Doncaster Sheffield Airport

Airspace Change Proposal for the Introduction of RNAV (GNSS) Departure and Approach Procedures

Sponsor Consultation Report
February 2018

Figure 5: Track Keeping data of Code 6160 for the month of August 2017

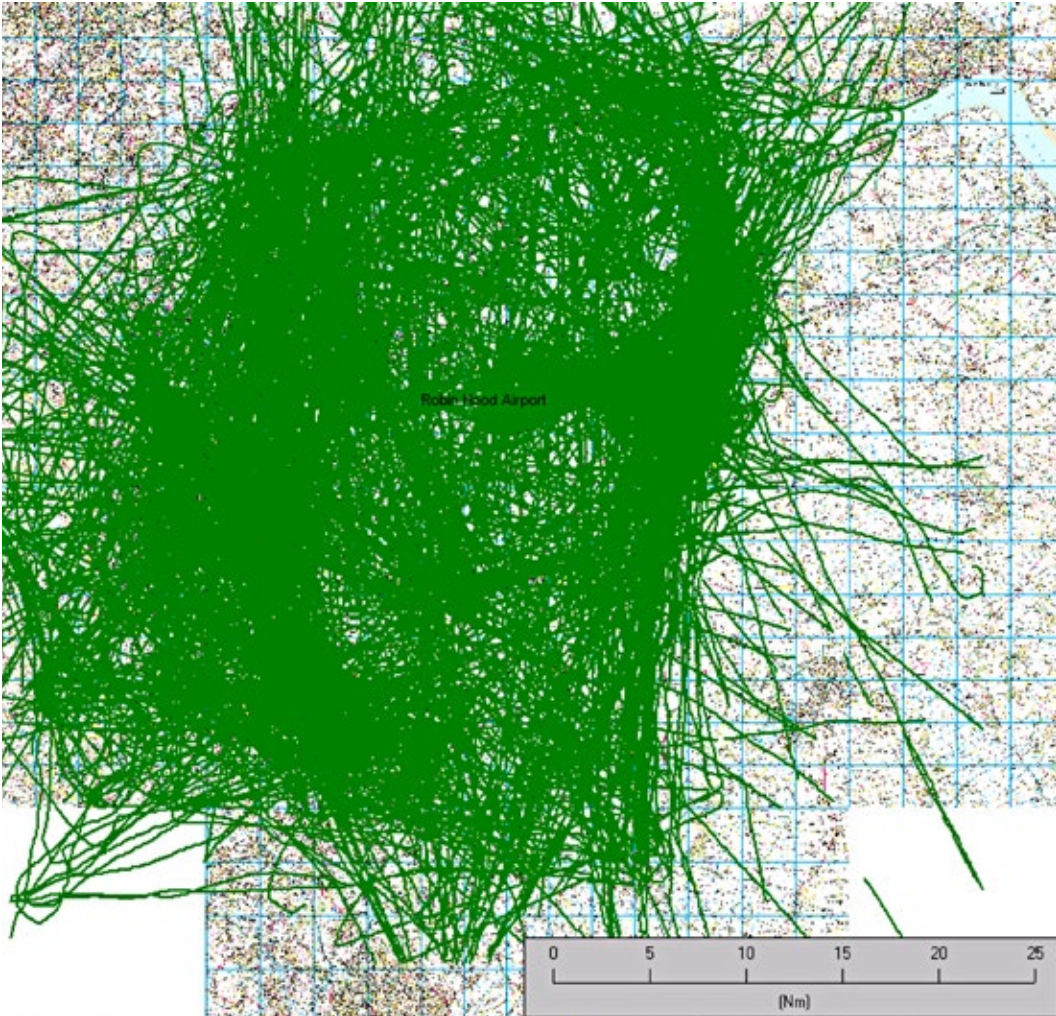
Seven objections to the additional portion of Controlled Airspace (CAS), (designated CTA X in the Consultation Document) to support controlled airspace containment of the ROGAG SIDs, resulting in less airspace being available to GA aircraft and resulting in a perceived safety issue as a result of creating 'choke' points.

We believe that the additional, small, portion of additional CAS is proportional to the requirement. No more controlled airspace than is necessary to contain the ROGAG SID has been proposed. There has been a general shift in traffic onto the ROGAG route since the DSA controlled airspace was established in 2008 and over 50% of CAT departures now depart via ROGAG.

The Preferred Departure Route (PDR) that exists today cannot be re-published, it must be replaced with a SID. The CAA expects that SIDs be contained within CAS unless a Safety Case can be written to their satisfaction.

It is appropriate that CAT traffic be afforded the protection that Class D airspace provides, hence our proposal.

We do not view the Class D airspace under our jurisdiction as an "exclusion zone" for GA traffic and our Air Navigation Services Provider most definitely does not routinely deny access to, or crossings of, the DSA Control Zone (CTR) or CTAs.

Records maintained since 2014 indicate that ATC is facilitating an average of more than 17,500 GA (per annum) aircraft in and around the DSA airspace with a majority being provided airspace crossings.

The figure below is indicative of the level of service provided to the GA community during a single month, the data is extracted from the 'Track Keeping' equipment and it is clear that GA community are accommodated in a diverse number of routes in and across the airspace for which DSA is responsible. The system has extracted only those aircraft allocated the 'conspicuity' code, 6160, which is generally given to GA traffic under a Basic Service. If a Traffic Service is required then a specific squawk code is allocated.

We believe the proposal will enhance the safety environment through the continued accommodation of GA aircraft across the airspace system resulting in the minimisation of 'choke' points. Safety is improved where communication is effective.
